**Re: Empire Aggregate, Inc.; Douglas Mountain Mine; M-2018-016;
112c Permit Application Amendment (AM-01) Geotechnical Model Adequacy Review**

6.5 Geotechnical Stability Exhibit

Analysis 1

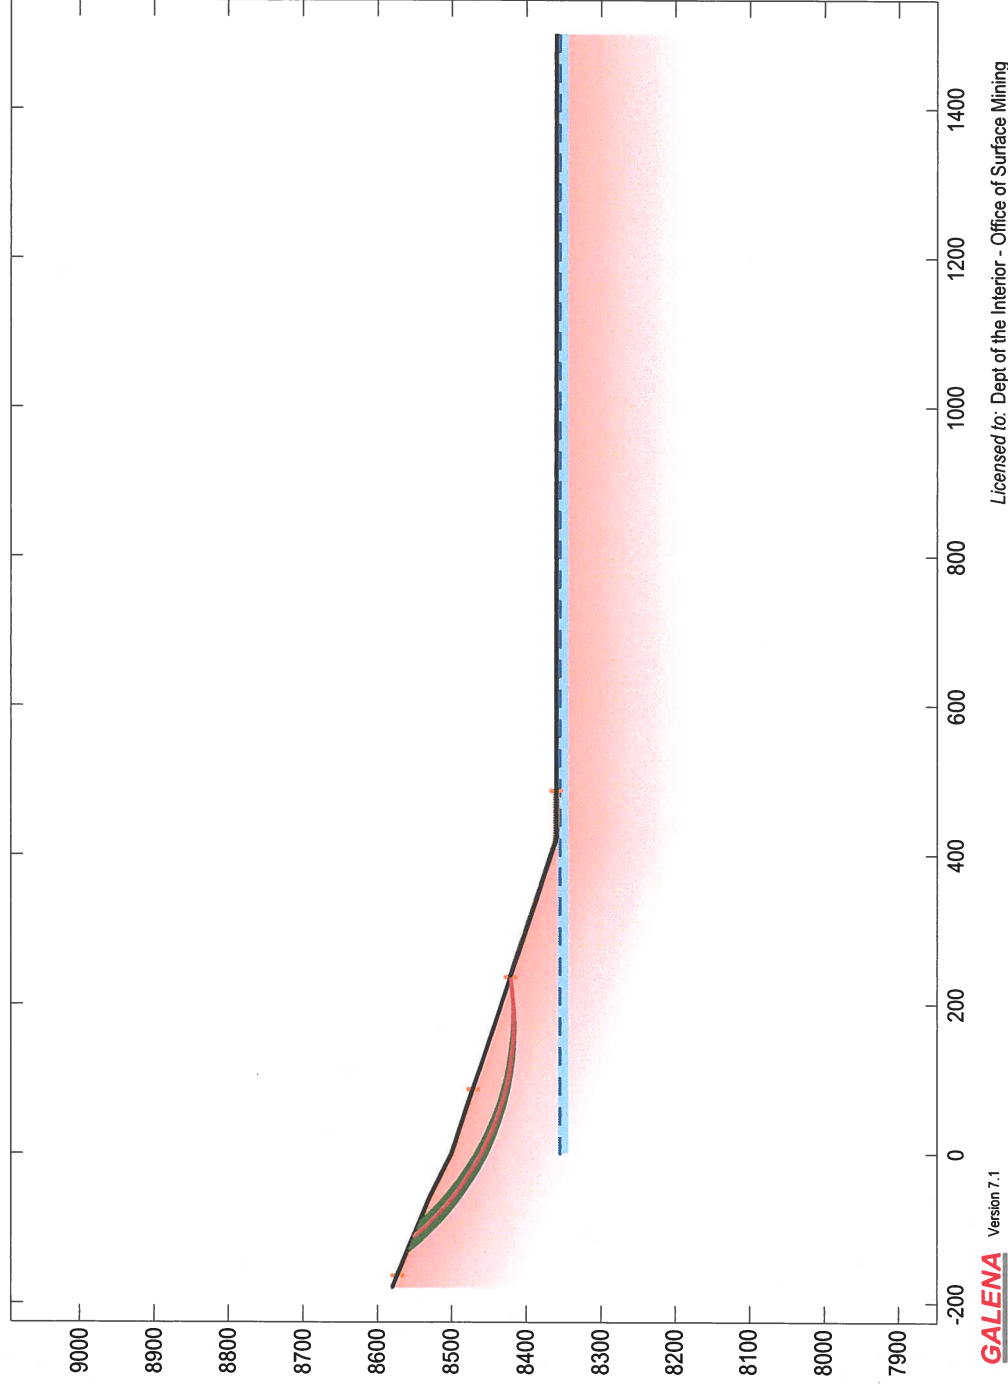
Applicant's Galena Results	DRMS Galena Results	DRMS Galena Results
Analysis 1	3.04	3.04	2.29*
Analysis 2	2.55	2.55	1.92*
Analysis 3	2.11	2.11	1.59*
Analysis 4	2.00	2.00	1.51*

Analysis 2

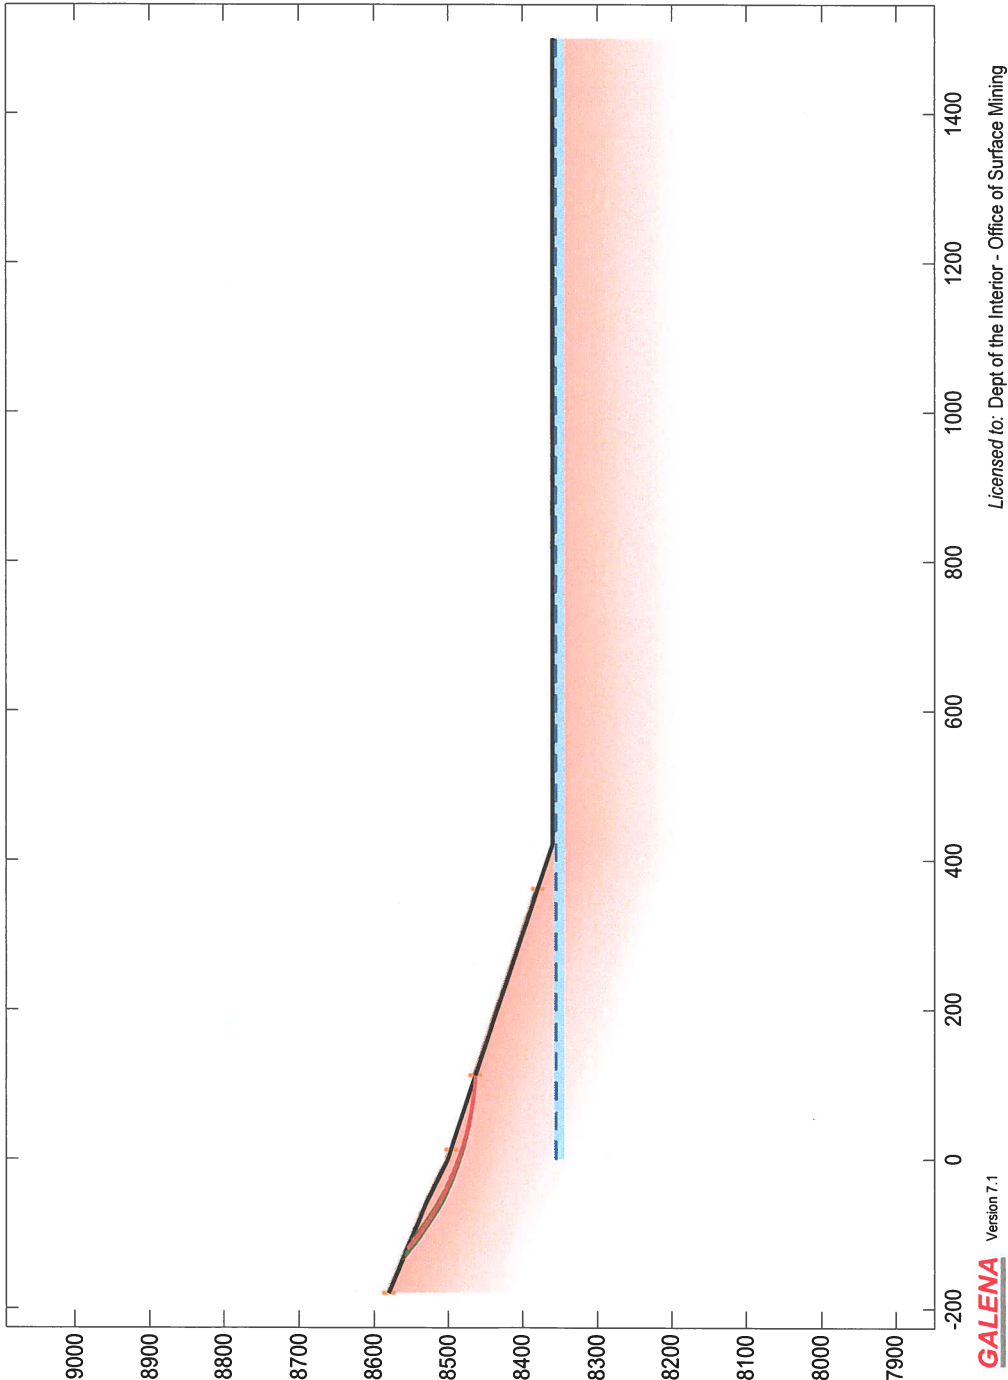
The Division typically accepts a lower friction angle for stability analysis models without laboratory strength test then was used by the Applicant. The Division's models indicated with an asterisk (*) were modeled with a reduced internal friction angle of 37 degrees.

Analysis 4

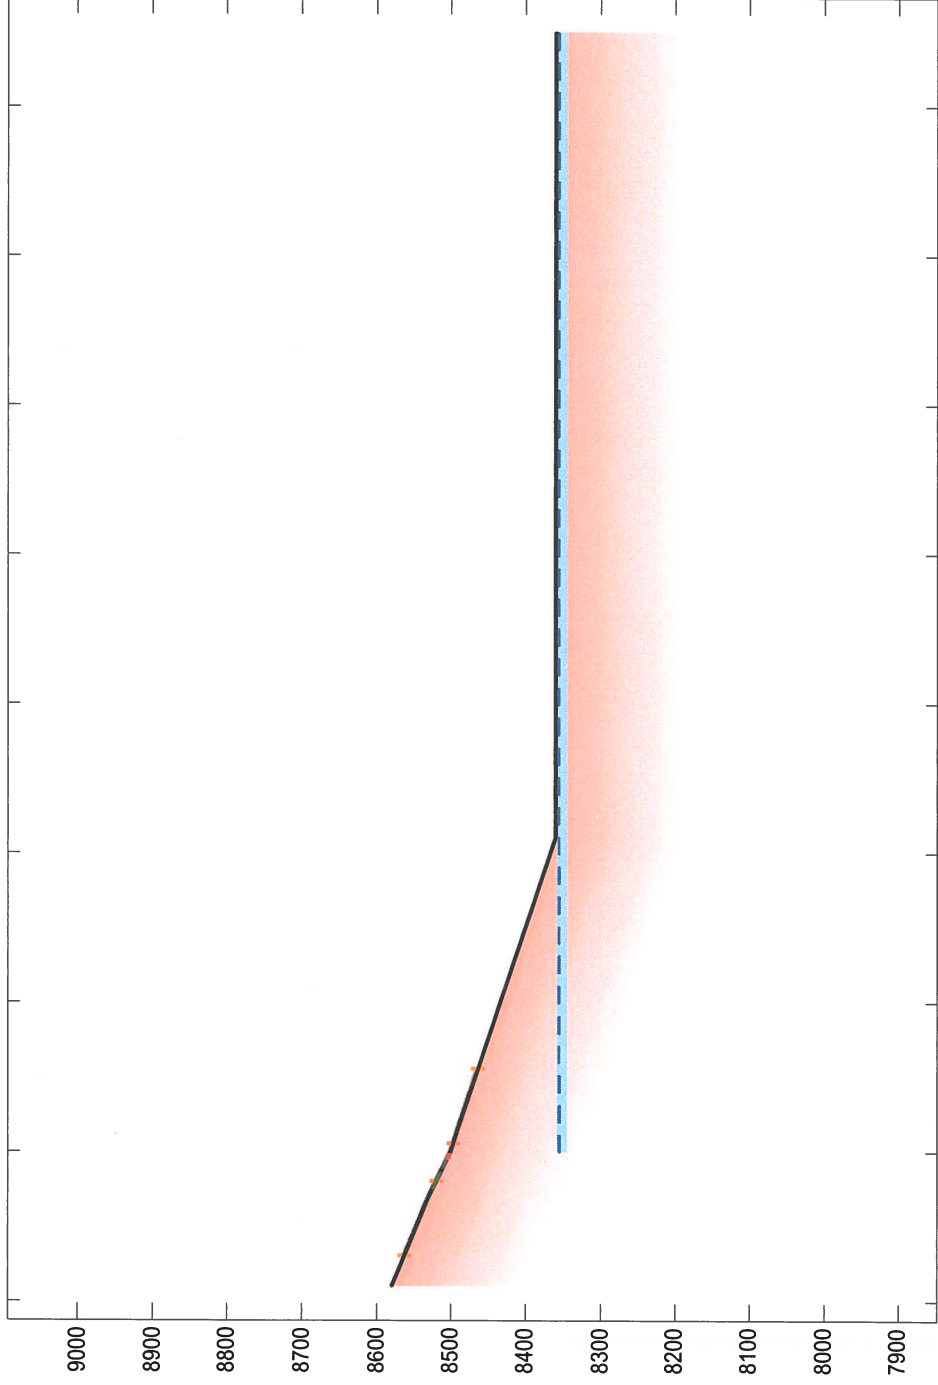
The Division requires a factor of safety of 1.5 for static models utilizing generalized, assumed, or single test strength measurements for critical structures. Please reference Section 30.4 - Guidance for Stability Criteria and Use of Minimum Factors of Safety in the Policies of The Mined Land Reclamation Board, May 16, 2018 effective date. The Policy document is available on the Division's website at: <https://mining.state.co.us/SiteCollectionDocuments/MLRB%20Policies%20Revised%20May%202018.pdf>
